SUBJECT: Initial Drafts of:

MIL-PRF-32535B (Capacitor, Chip, Fixed, Ceramic Dielectric (Temperature Stable and General Purpose), Extended Range, High Reliability and Standard Reliability, General Specification for)

NOTE: This draft, dated 20 December 2022, prepared by DLA-CC, has not been approved and is subject to modification.
DO NOT USE PRIOR TO APPROVAL. (Project 5910-2023-007)

INCH-POUND
MIL-PRF-32535BA
~~31 October 2017~~ **DRAFT**
SUPERSEDING
MIL-PRF-32535A
~~28 September 2015~~ **31 October 2017**

FIGURE 5. Board flex.

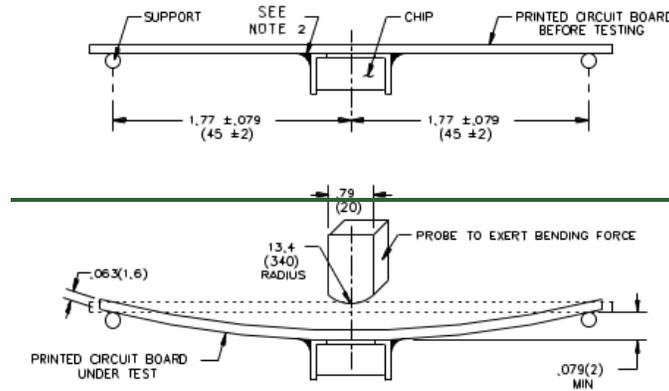
4.6.9 Board flex (see 3.13). Capacitors shall be tested in accordance with MIL-STD-202-218. The following details and exceptions shall apply: ~~for board flex in accordance with the following:~~

- a. Mounting: Capacitors shall be mounted in accordance with 4.3.5 ~~on a 3.94 inches (100 mm) \pm 0.079 inch (2.0 mm) X 1.57 inches (40 mm) \pm 0.079 inch (2.0 mm) FR4 PCB, which is 0.063 inch (1.6 mm) \pm 0.008 inch (0.20 mm) thick. Epoxy adhesives, if applicable (see 4.3.5), shall be limited to the terminations only.~~ At the option of the manufacturer, the length and width of the PCB may be increased to allow for electrical test connections and multiple samples to be mounted and subjected to the board flex test. Testing and all other dimensions shall remain as specified.

- b. Procedure: ~~The FR4 PCB shall be placed into a fixture similar to the one shown in figure 5 with the component facing down. The position of the support rails shall be as specified in figure 5 and the capacitor and loading probe shall be centered between the rails. A force shall be applied which will bend the board 0.079 inch (2.0 mm), minimum. The force shall be applied to the board only once.~~

~~At the option of the manufacturer, the configuration of the PCB and fixture may be vertical or horizontal provided the force applied is in the direction specified in figure 5.~~

~~FIGURE 6. Shear stress.~~

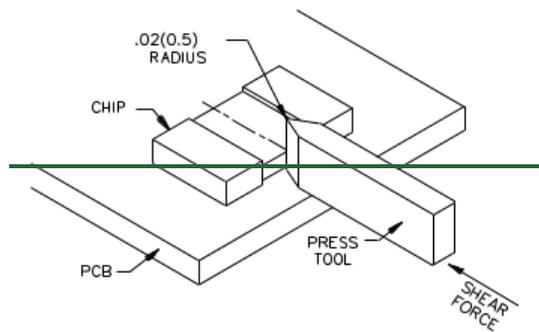
- a. Mounting: Capacitors shall be mounted in accordance with 4.3.5. Epoxy adhesives, if applicable, shall be limited to the terminations only (see table IV).
- b. Procedure: The specified force shall be applied to the side of the capacitor being tested (see figure 6). The applied force shall be parallel with the plane of the test board and perpendicular to the side of the capacitor. The force shall be applied gradually as not to apply a shock to the capacitor being tested.
- c. Duration of force: The force shall be applied for 60 seconds \pm 1 second.
- d. Magnitude of force applied:

- e. Examination after test: Capacitors shall be visually inspected for mechanical damage to the capacitor body, terminals, and body/terminal junction (see 4.3.6).
